Description of Changes - NUREG-1431 Section 3.01.05

13-Nov-99

DOC Number	DOC Text																																										
A.01	In the conversion of Point Beach current Technical Specifications (CTS) to the proposed plant specific Improved Technical Specifications (ITS), certain wording preferences or conventions are adopted which do not result in technical changes (either actual or interpretational). Editorial changes, reformatting, and revised numbering are adopted to make the ITS consistent with the Standard Technical Specifications, Westinghouse Plants, NUREG-1431, Revision 1 (i.e., Improved Standard Technical Specifications (ISTS)).																																										
	<table><thead><tr><th>CTS:</th><th>ITS:</th></tr></thead><tbody><tr><td>15.03.10</td><td>LCO 3.01.04</td></tr><tr><td>15.03.10.B.01</td><td>LCO 3.01.04</td></tr><tr><td>15.03.10.B.01.A.03</td><td>SR 3.01.04.01</td></tr><tr><td>15.03.10.B.01.A.03.A</td><td>LCO 3.01.04 COND A</td></tr><tr><td>15.03.10.B.01.A.03.B</td><td>LCO 3.01.04 COND A RA A.1.1</td></tr><tr><td>15.03.10.B.01.B.01</td><td>LCO 3.01.04 COND A RA A.1.2</td></tr><tr><td>15.03.10.B.01.B.01.A</td><td>LCO 3.01.04 COND A RA A.2</td></tr><tr><t

FIGURE 15.3.10-1

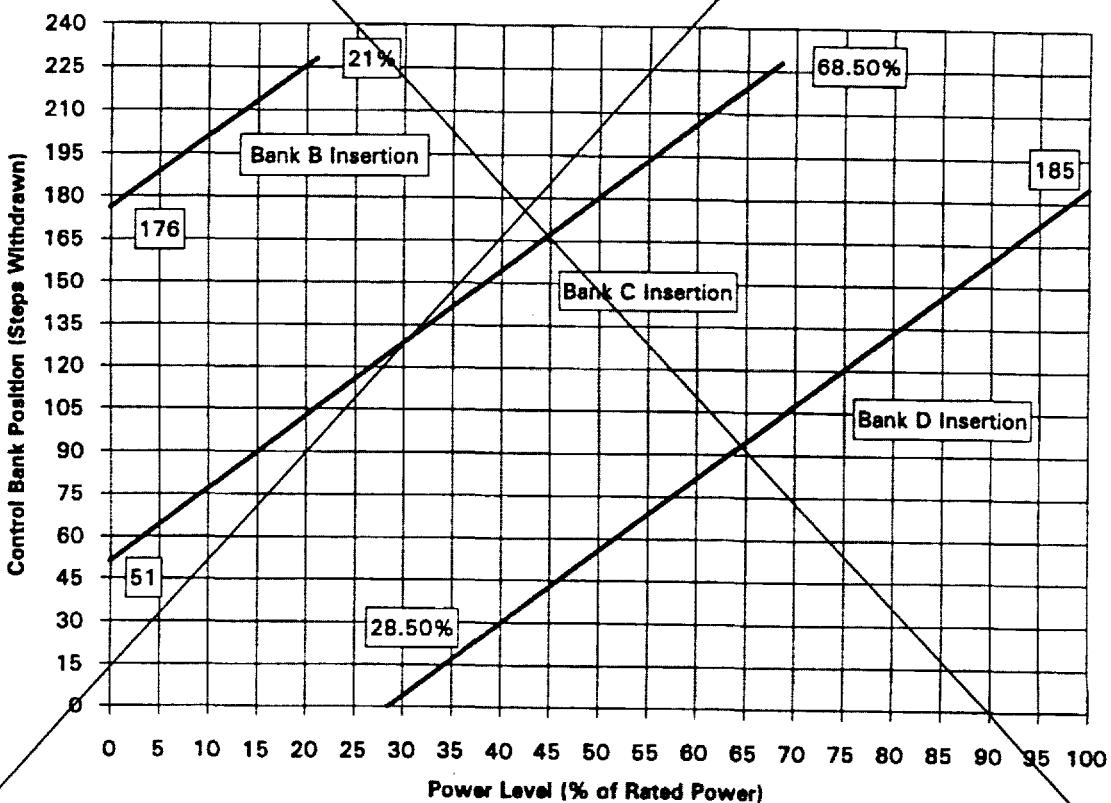
When the insertion limits are observed and the control rod banks are above the solid lines shown on Figure 15.3.10-1, the shutdown requirement is met. The maximum shutdown margin requirement occurs at end of core life and is based on the value used in analysis of the hypothetical steam break accident. Figure 15.3.10-2 shows the shutdown margin equivalent to 2.77% reactivity at end-of-life with respect to an uncontrolled cooldown. All other accident analyses assume 1% or greater reactivity shutdown margin. Shutdown margin calculations include the effects of axial power distribution. The accident analyses assume no change in core poisoning due to xenon, samarium or soluble boron.

Figure B 3.1-1 (page 1 of 1)
Control Bank Insertion vs. Percent RTP

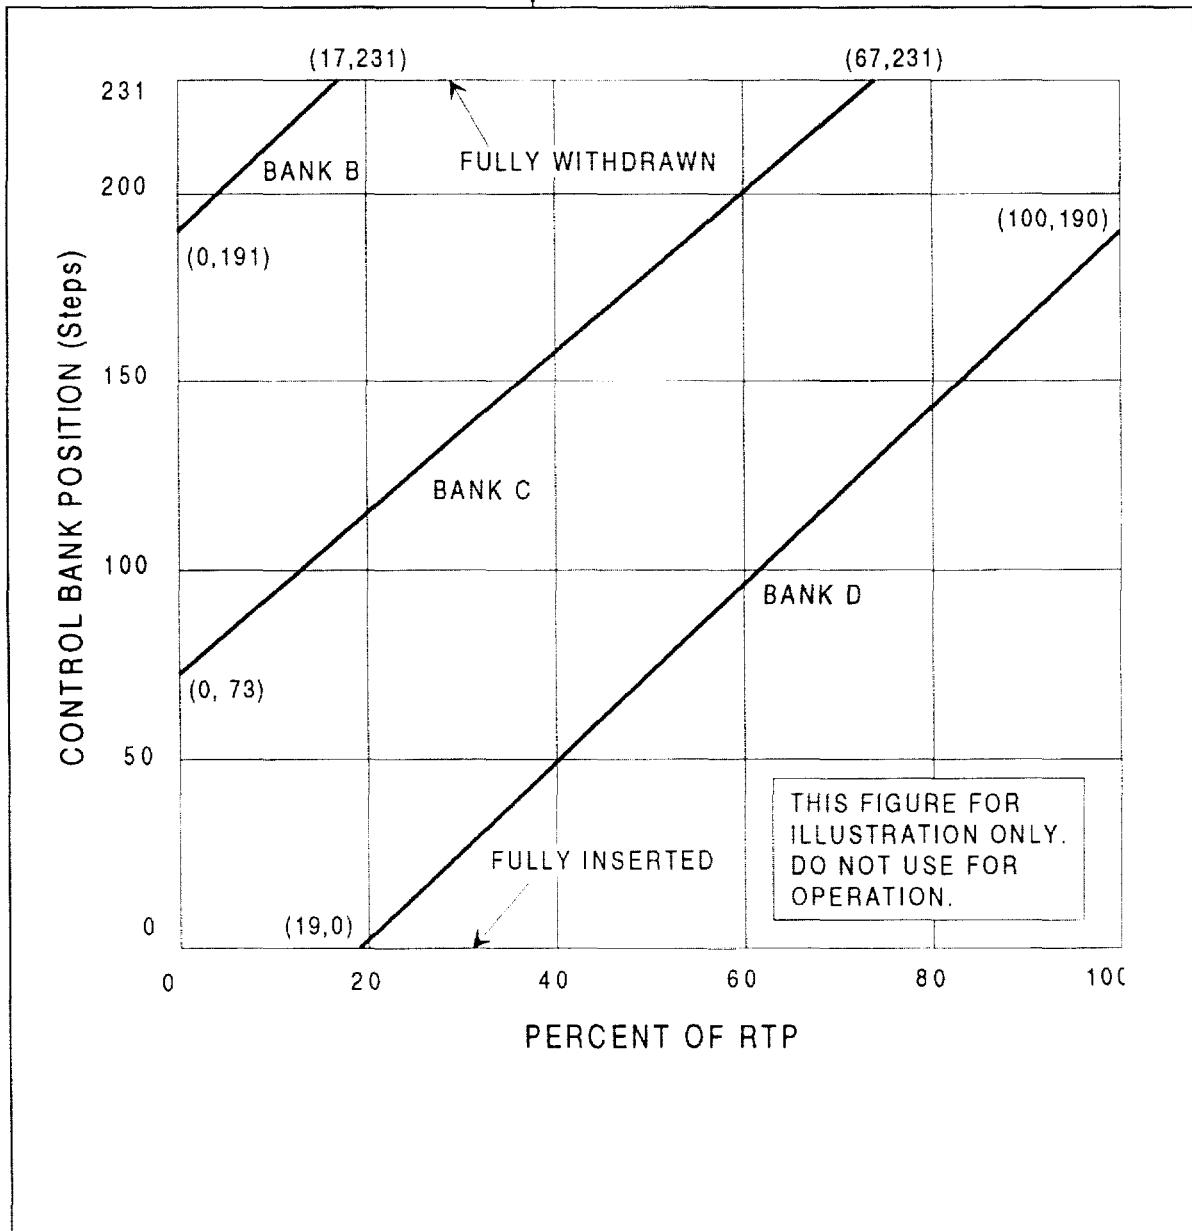
JFD Number	JFD Text
06	<p>Figure B 3.1.7-1, "Control Bank Insertion Limits" is provided in the Bases of the ITS as an example of the rod insertion limits in addition to a reference in explaining the concept of bank overlap. This figure has been retained, but as a generic figure for information only to eliminate any possible confusion as to the figure's use. Plant specific information is contained in the COLR.</p> <p>ITS: B 3.01.06</p> <p>NUREG: B 3.01.07</p>
07	<p>The Mode of Applicability for NUREG LCO 3.1.7 is Mode 1 and 2 with Keff greater than or equal to 1.0, while the default Required Action (C.1) requires the unit to be placed into Mode 3 within 6 hours. LCO 3.0.2 states that an LCOs Required Actions are no longer applicable if an LCO is met or no longer applicable. Accordingly, the Required Actions are no longer applicable after the unit reaches Mode 2 with Keff less than 1.0. Therefore, the default action has been revised to require the unit to be placed into Mode 2 with Keff less than 1.0 within 6 hours to establish continuity between the General Usage LCOs and the Required Actions for NUREG 1431 LCO 3.1.7. This implements approved TSTF 238, Revision 0.</p> <p>ITS: B 3.01.06 LCO 3.01.06 COND C RA C.1</p> <p>NUREG: B 3.01.07 LCO 3.01.07 COND C RA C.1</p>

Replace with generic
Figure
